### THE MARYLAND-NATIONAL CAPITAL PARK AND PLANNING COMMISSION

Preliminary Plan Review

Resubdivision of Lot 45, Clark Meadows

1-02069

Timber Creek / Clark Meadows Lot #43 Foreman North Side of Entry

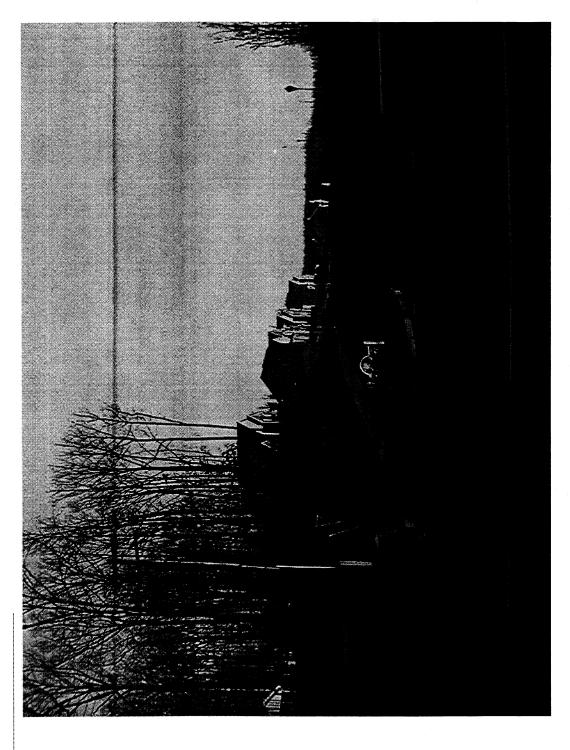
- Counter to Community Layout
- Community Lot Layout includes maintenance of old-growth trees where possible
- Currently "Developer-Landscaped" Symmetrical Entryway to Community
- Counter to Community "Standards"
- Street Frontage
- Lot Size
- House Size (Land Improvements)

Lot #43 Entry Community Landscaping Timber Creek / Clark Meadows

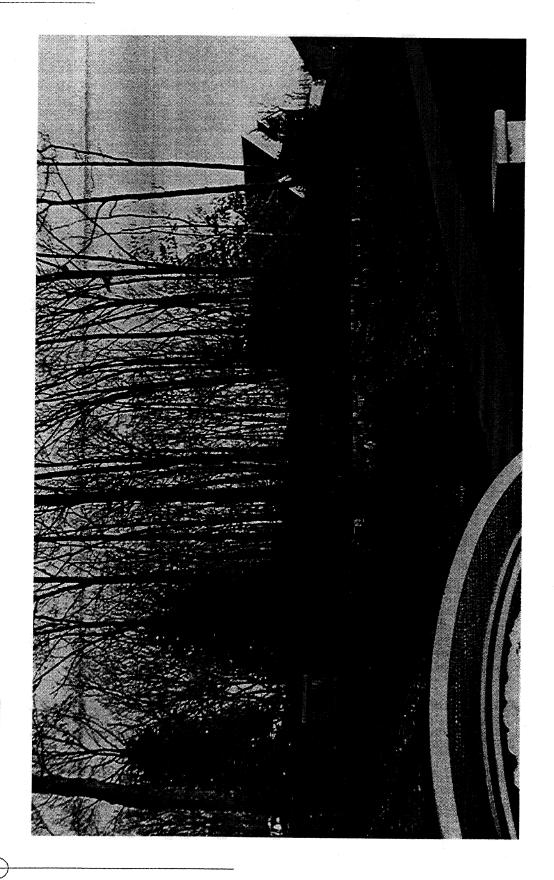
- Proposed Subdivision plans would eliminate the existing symmetry between the South and North side of Foreman Boulevard which serves as the community entrance

Timber Creek / Clark Meadows Entrance Lot #45 Entry Community Landscaping

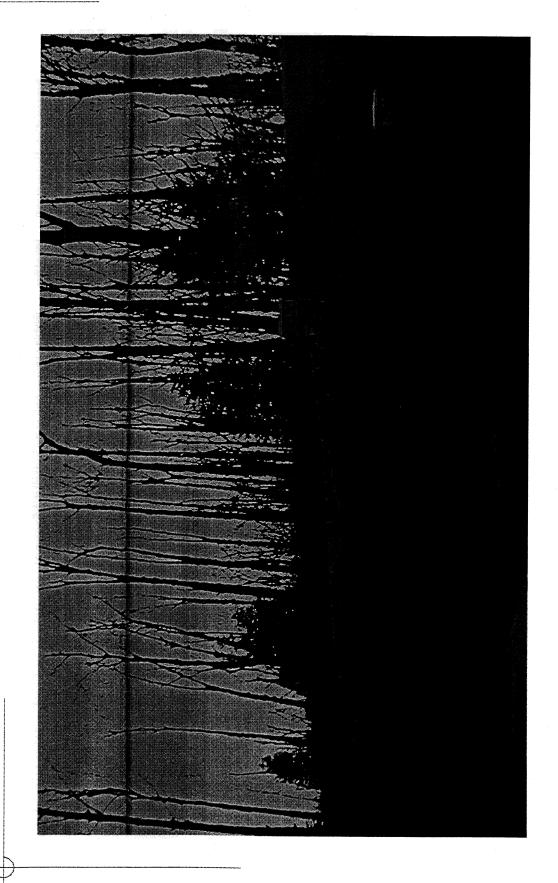
- 1. Elm Street's proposed revision and subdivision of "Lot 45" does not retain the existing symmetry of our community entrance landmarks and old-growth trees that were 'bought-into' by all existing homeowners as a result of preliminary plans on file for Lot 45 submitted to M-NCPPC as well as landscaping property improvements and grading that were completed by Elm Street prior to purchase decision of community residents. If existing plans were placed on file without actual intention to develop as filed, as well as inclusion of Lot 45 in our residential covenants as a "cornerstone" to our community, it would appear to be an attempt to mislead potential consumers which were making buying decisions within the community (that seems to be offensive, if not criminal in nature).

- Proposed Subdivision plans would require the shared driveway to traverse the complete front
    of one of the newly developed lots, and would necessitate maintenance of 4-foot brick wall
    across the entire front of the other subdivided lot for retention of community entrance
    monuments as represented by Mr. Flanagan.
